Redford Park Protected Signalised Junction  
Stage 1 Road Safety Audit

Wicklow County Council

## Stage 1 Road Safety Audit

Drawing No.	Drawing Title	Revision
190092-DBFL-RD-SP-DR-C-1901	Redford Park Redford Park Protected Signalised Junction OPTION A	P01

Figure 2.2 – Possible Vehicle Trajectory through 'Cycle Only' Areas

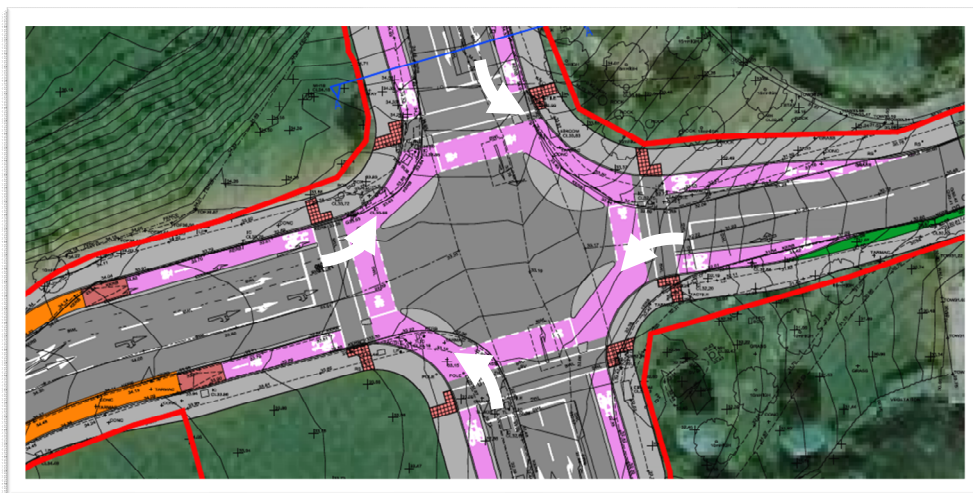
### 2.2 Problem: Errant Vehicles Accessing 'Cycle' Only Areas

**Location:** Behind Protective Islands

Errant drivers may enter 'cycle only' areas, placing cyclists at risk of conflict with general traffic.

The potential for vehicle entry to these locations should be physically restricted.

Figure 2.3 – Existing Right Turn Lane Serving Cemetery

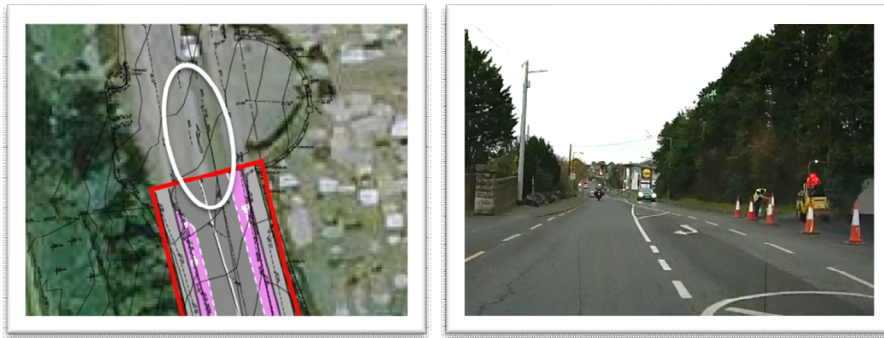
## 2.3 Problem: Insufficient Width for Right Turn Lane

**Location:** Existing Right Turn Lane Serving Redford Cemetery

The proximity of the northern scheme tie-in could result in there being insufficient cross section to incorporate the existing lane configuration which includes a northbound lane, right turning lane and southbound lane. This could result in side swipe and opposition type conflicts.

The following options are proposed to mitigate the risk described:

1. Remove the right turn lane and utilise the space it occupied to maintain two opposing traffic lanes, improved footpath widths and continuous cycle lanes on approach to the junction.
2. Maintain the right turn lane and move the northern scheme tie-in south to the commencement of the central hatched area serving the existing cemetery right turn lane.

Figure 2.4 – Alignment of Westbound Approach for Straight Ahead & Left Turn Movements

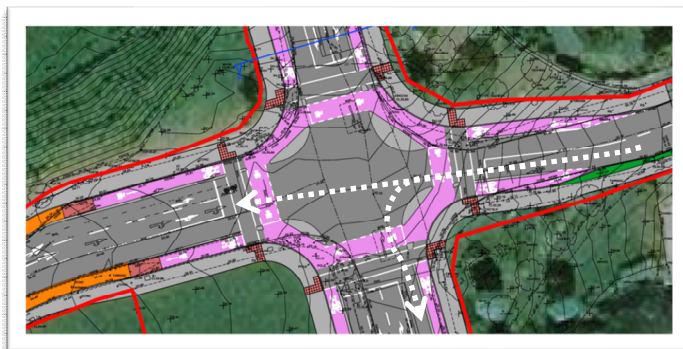
## 2.4 Problem: Side Road Approach Alignment

**Location:** Redford Park – Westbound Approach

The right hand horizontal curve on the immediate westbound approach to the junction:

1. Directs drivers into the opposing traffic lane on the eastbound approach arm.
2. Makes the left turn onto the R761 more challenging for drivers to negotiate.

A swept path analysis should be undertaken on the movements described, with a view to improving the approach alignment of the Redford Park westbound approach if required.
